February 27, 2015
SBK-L-15026
Docket No. 50-443

Seabrook Station

NextEra Energy Seabrook, LLC's Fourth Six-Month Status Report in Response to March 12, 2012 Commission Order Modifying Licenses with Regard to Reliable Spent Fuel Pool Instrumentation (Order Number EA-12-051)

Design Requirements for the Westinghouse Supplied Level Monitoring Equipment

Seabrook SFPIS Mounting Bracket

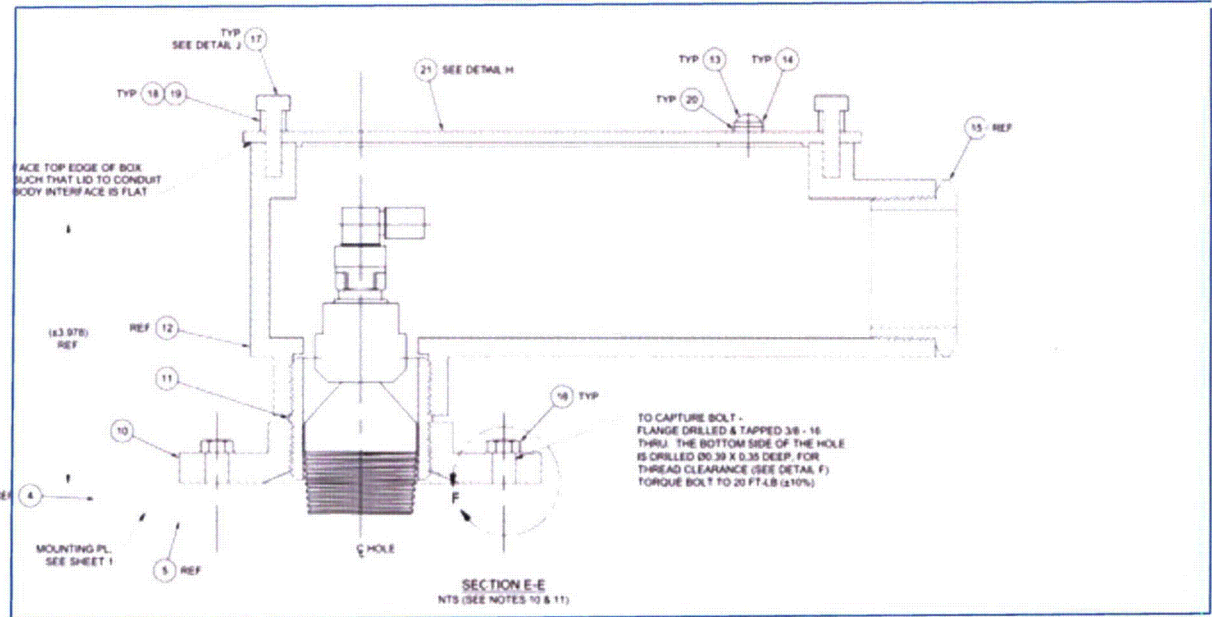
#	Topic	Parameter Summary	Westinghouse Reference Document Number	Additional Comment	Test or Analysis Results	Licensee Evaluation
12	Pool-side Bracket Seismic Analysis	N/A	CN-PEUS-14-16	Analysis included seismic forces and hydrodynamic forces, as appropriate.	Passed	See response to NRC Question. 4. Seabrook seismic requirements to withstand a SSE are bounded by the Westinghouse analysis for the poolside mounting bracket. Equipment anchorage will be designed by Seabrook to meet the calculated Westinghouse loads (tension and shear loads, and hydrodynamic load) with appropriated safety margin.
13	Additional Brackets (Sensor Electronics and Electronics Enclosure)	N/A	WNA-DS-02957-GEN	Weights provided to licensees for their own evaluation.	N/A	Equipment anchorage will be designed by Seabrook to meet the calculated Westinghouse loads (tension and shear loads, and hydrodynamic load) with appropriated safety margin.
